Subject: Limerick Generating Station, Units 1 and 2
Additional Information for Auxiliary Systems
Branch (ASB) Regarding SER Open Issue #2
(Tornado Missile Effects on Ultimate Heat Sink).

RESPONSE TO
QUESTIONS AND COMMENTS CONCERNING REPORT NUS-4507
LIMERICK GENERATING STATION, ULTIMATE HEAT SINK EXTREME
WIND HAZARD ANALYSIS

Figure 1. Straight Wind Hazard Curves

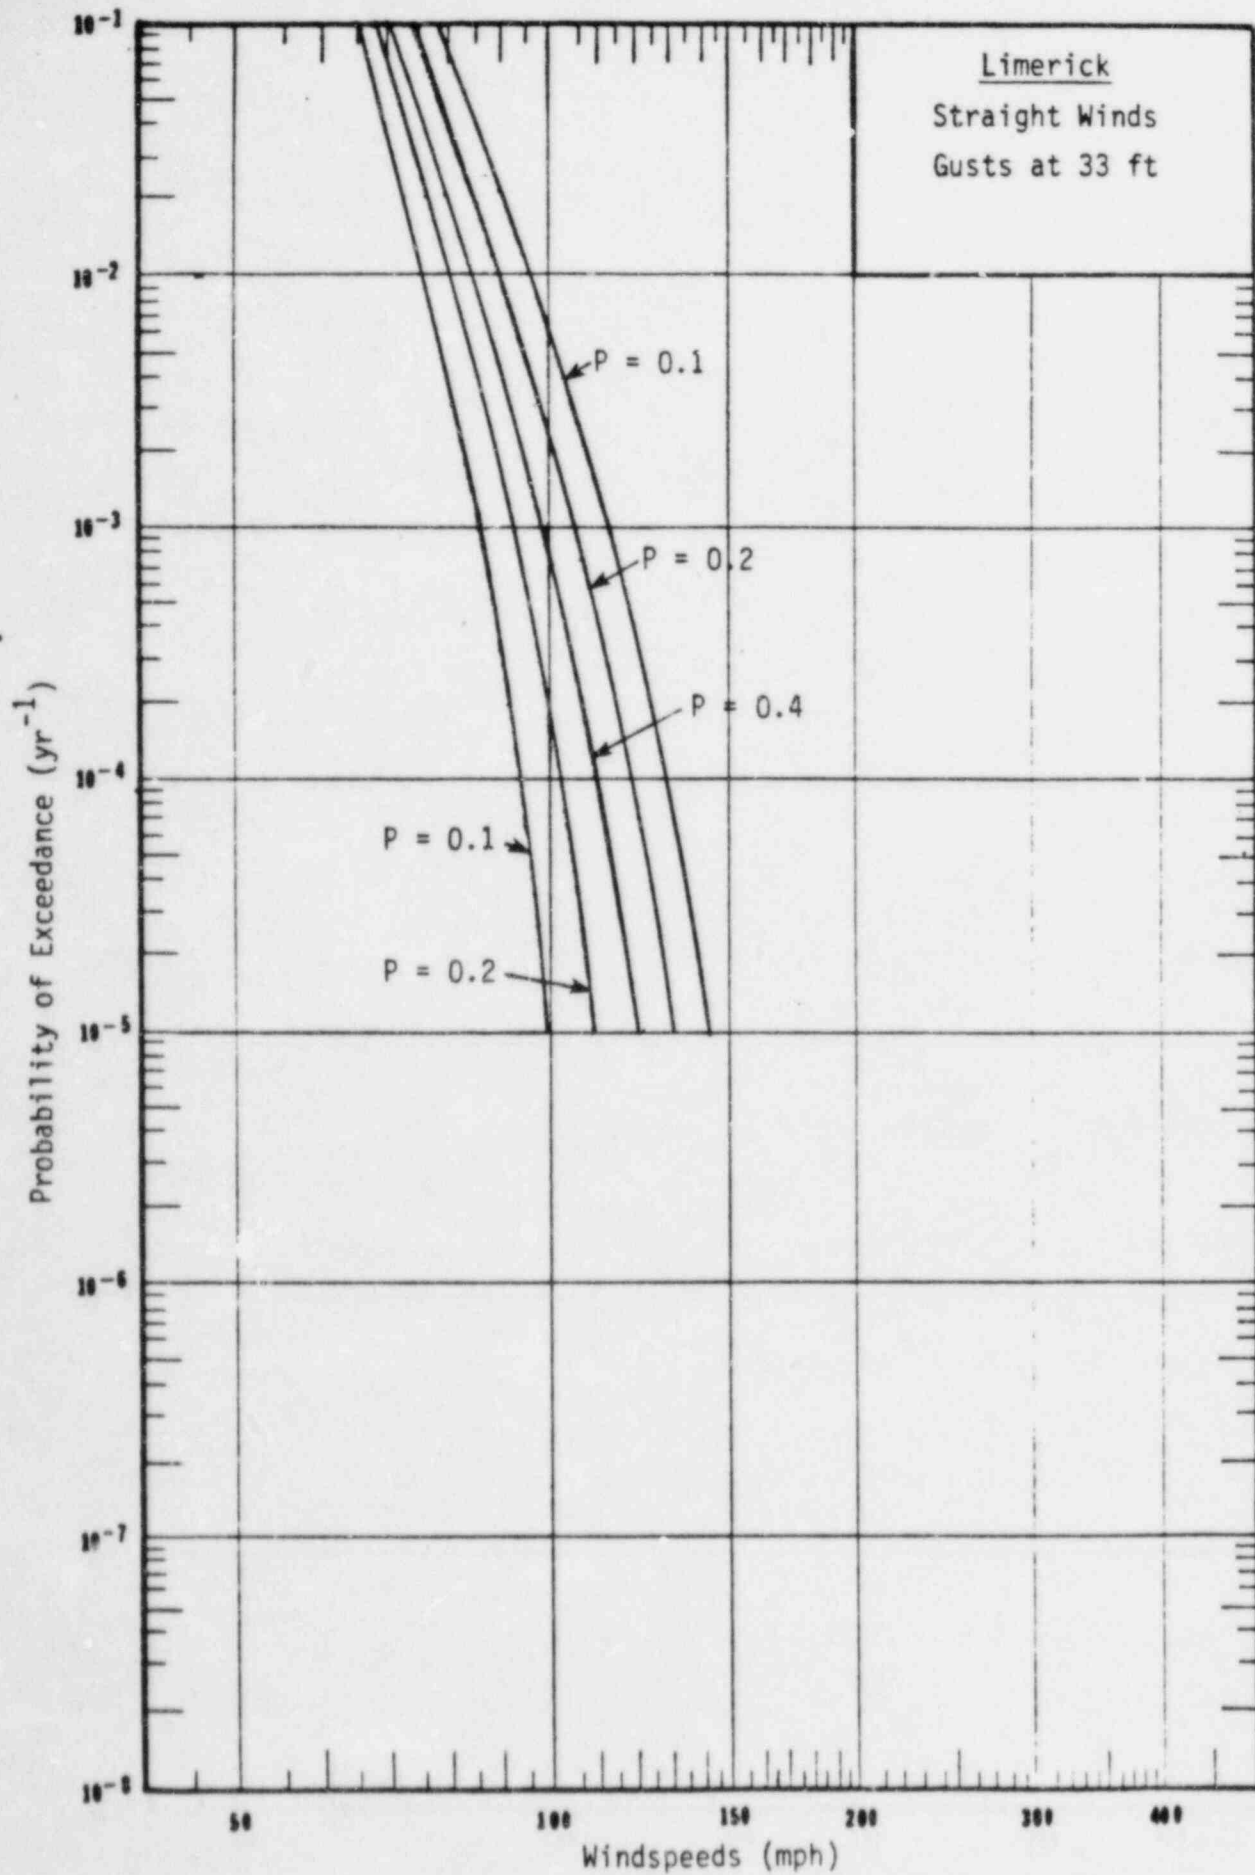
What is the expected effect of accounting for sampling errors in estimating "straight" and hurricane wind speeds upon the estimated frequencies of exceeding 10 CFR Part 100 limits?

It was indicated in the review meeting that the NRC staff had used the Harrisburg, Pennsylvania, data (39 years of record) curve in its preliminary investigation of Limerick. This curve produces windspeeds very similar to the Reading data. The effect of sampling error for the straight wind frequencies is illustrated in Figure 1

for the Reading data based on an equivalent 28 years of record, which is one-half of the actual record length at Reading. Hence, the sampling errors are effectively increased by $\sqrt{2}$ to account for extrapolation to the site. A family of curves is plotted based on normally distributed errors, which were computed using the method of moments. This family of curves is plotted at $\{\hat{\mu} - 1.76\hat{\sigma}, \hat{\mu} - 0.859\hat{\sigma}, \hat{\mu}, \hat{\mu} + 0.859\hat{\sigma}, \text{ and } \hat{\mu} + 1.76\hat{\sigma}\}$, which are the expected value locations of a discretized normal density with probabilities 0.1, 0.2, 0.4, 0.2, and 0.1, respectively.

Figure 2. Hurricane Hazard Curves

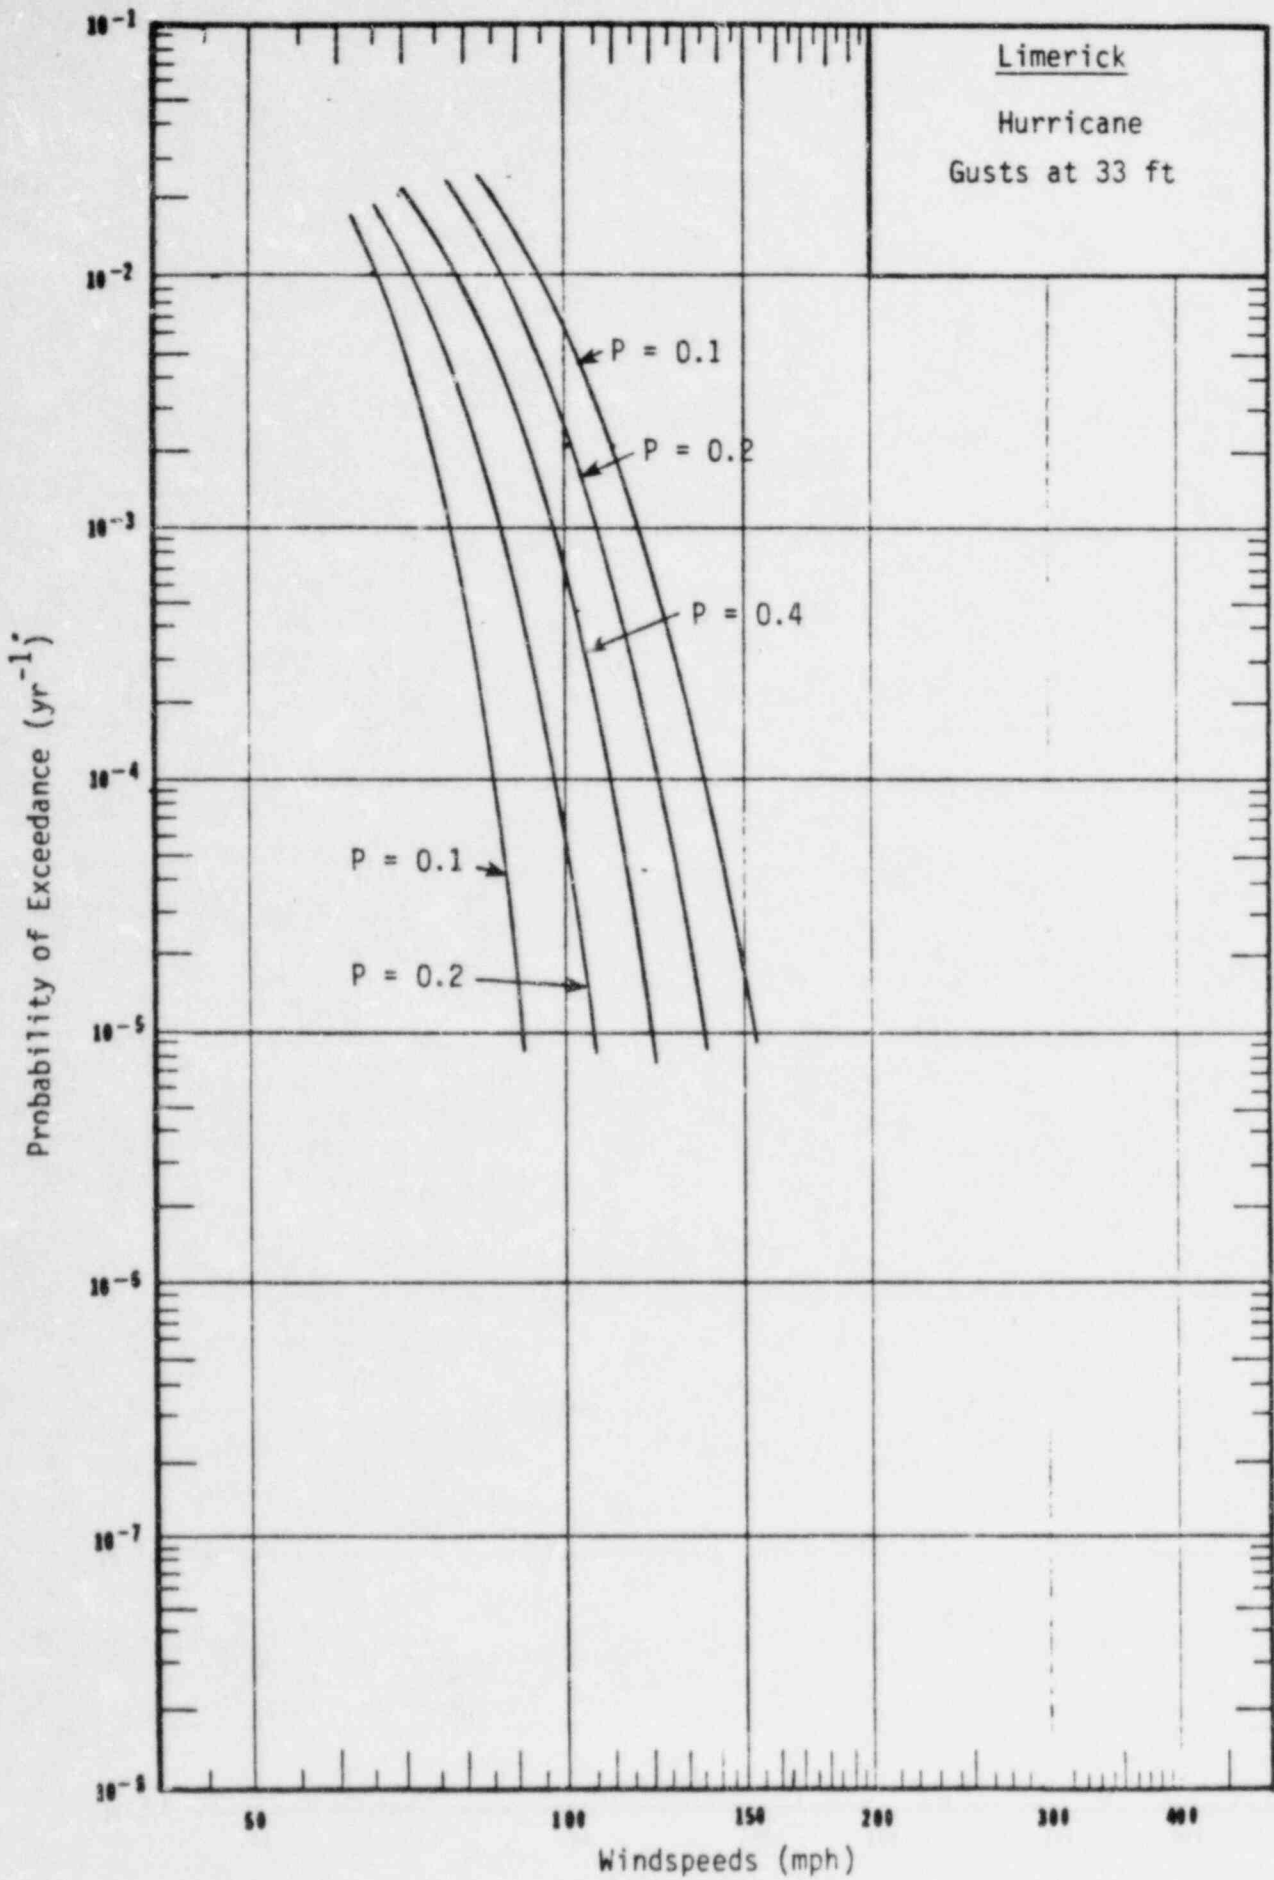
Sampling errors also are inherent in hurricane wind speed estimates (see Batts, et al., "Sampling Errors in estimation of Extreme Hurricane Winds," J. Str. Div., ASCE, October 1980, pp. 2111-2115).

(b) Hurricanes. Uncertainties in the hurricane curve for Limerick can be estimated using the results of the Batts et al. study. The following estimates of error are used:

Assuming that the results are linear and independent in these errors, the combined error can be estimated by summing the variance of each error source. One obtains $\hat{\sigma}_c = 0.117$ for $P(v > v^*) = 1 \times 10^{-2}$ and $\hat{\sigma}_c = 0.15$ for $P(v > v^*) = 2.5 \times 10^{-3}$. These uncertainties are plotted in fig. 2 for a discretized normal distribution with probabilities 0.1, 0.2, 0.4, 0.2, and 0.1. These uncertainties demonstrate a wider distribution than that estimated for the straight winds and thus tend to dominate the straight wind curves.

COOLING TOWER GENERAL ARRANGEMENT

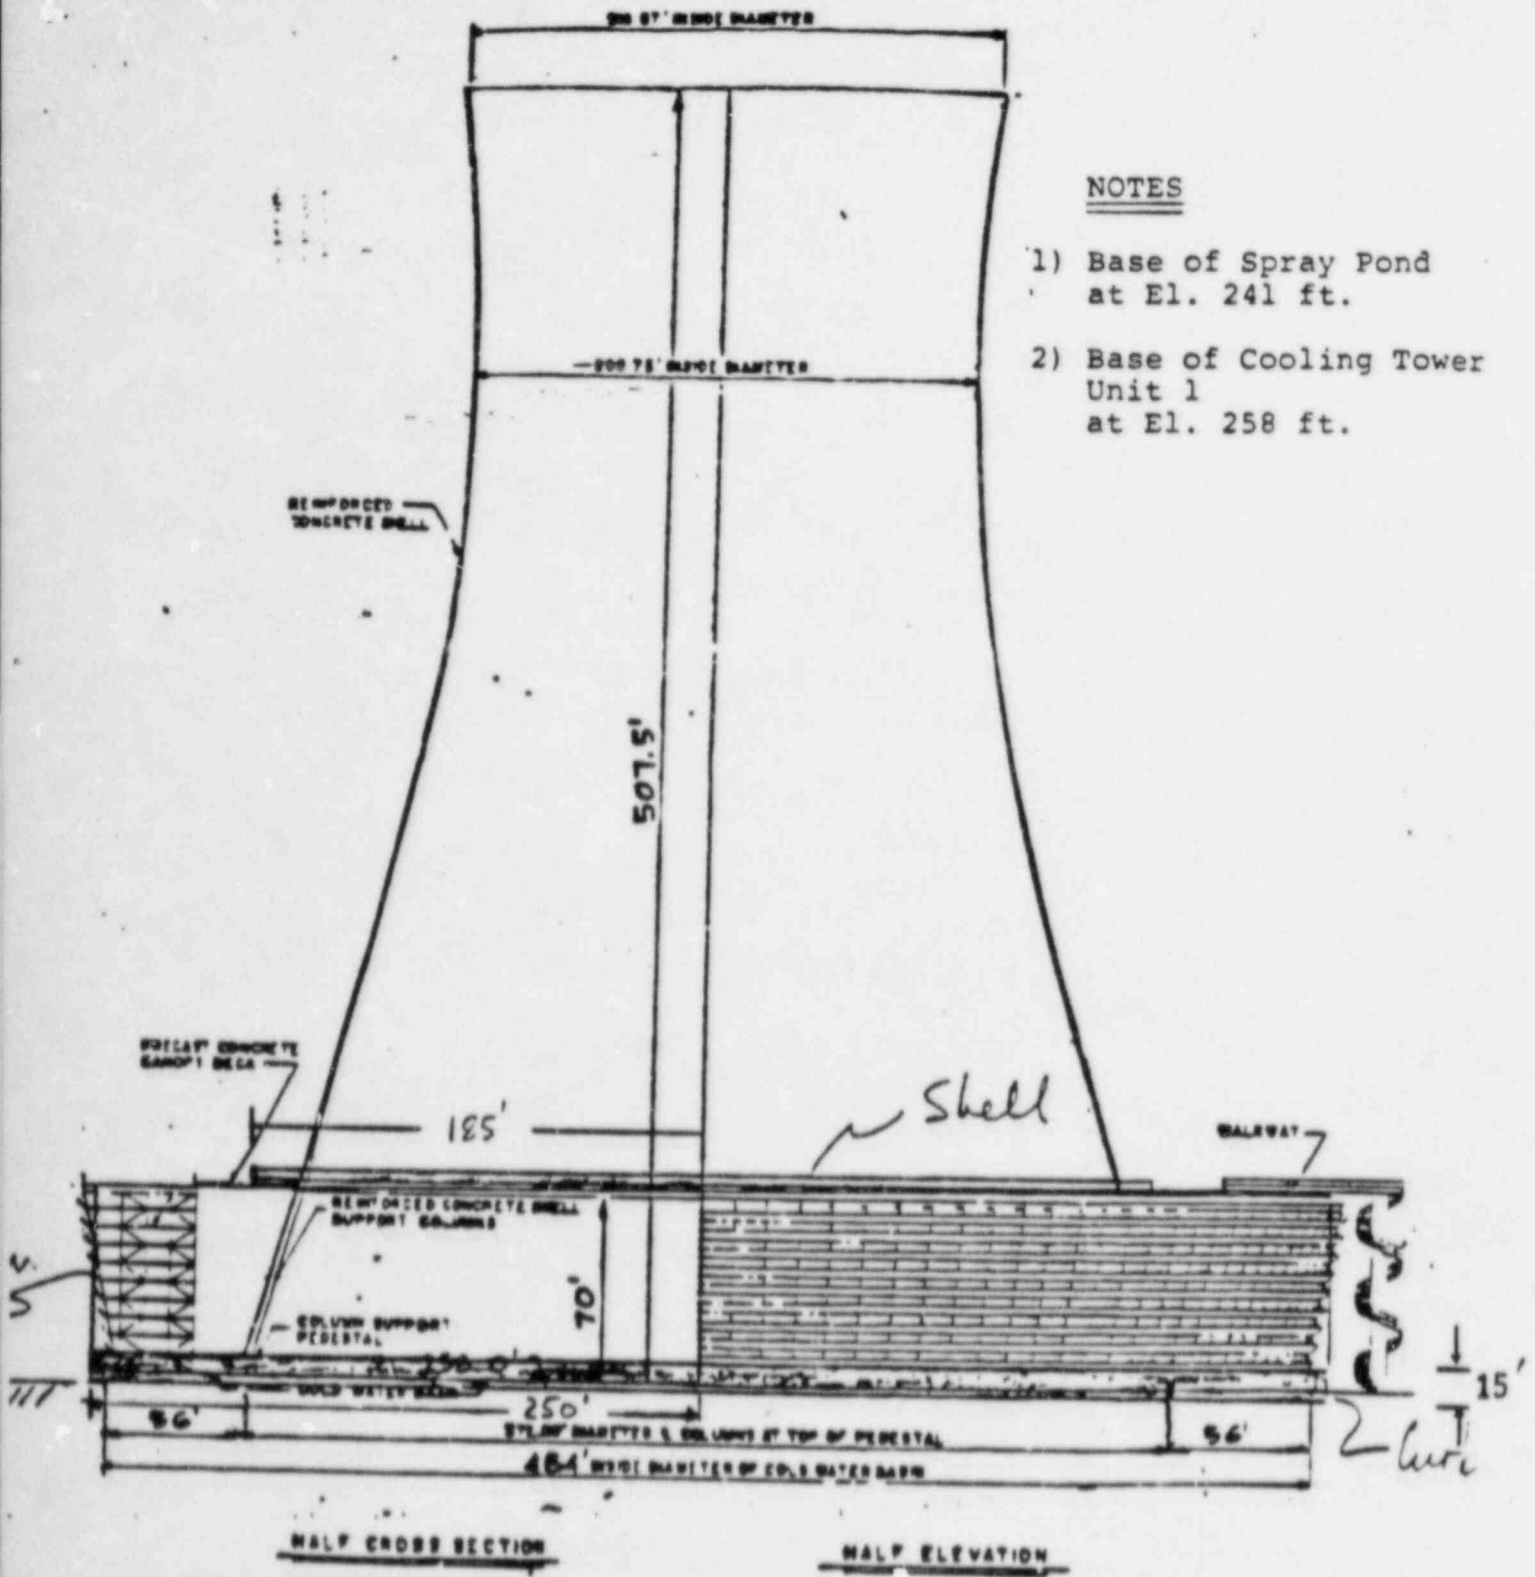
- a. What is the Report's definition of the basic wind speed? Is it the fastest-mile wind speed over open terrain?
- b. What is the precise definition of "designed for," i.e., was an allowable stress, or an ultimate stress approach used in the design of the tower for a basic wind of 90 mph?
- c. What are the heights of the towers? From p. 4-7 one might infer that they are 485 ft. Is this inference correct? What does the 500 ft elevation mentioned in line 2, Section 4.4.3.1 represent? A simple sketch of the towers should be included, indicating: the elevations of the top and bottom of the towers; the curb wall; and the fill areas.
- d. Is the 140 mph speed at which the towers are assumed to fail a speed averaged over 2 seconds?

- b. Allowable stress.
- c. See Figure 1.
- d. The TORMIS methodology conservatively simulates the peak windspeeds and tornados as steady-state winds. For example an F2 tornado with a peak wind of 150 mph (averaged over several seconds) would be simulated with a peak steady wind of 150 mph. The actual averaging time of peak tornado winds is generally felt to be on the order of several seconds since the tornado classification system is based on observations of structural damage. (Fujita assumes that the windspeeds in the F-scale are fastest quarter mile speeds.) Thus, the tower failure criteria is based on windspeeds without any explicit consideration of averaging time. If the centerline of the tower experiences windspeeds of any duration 140 mph at tower midheight the tower is assumed to fail.
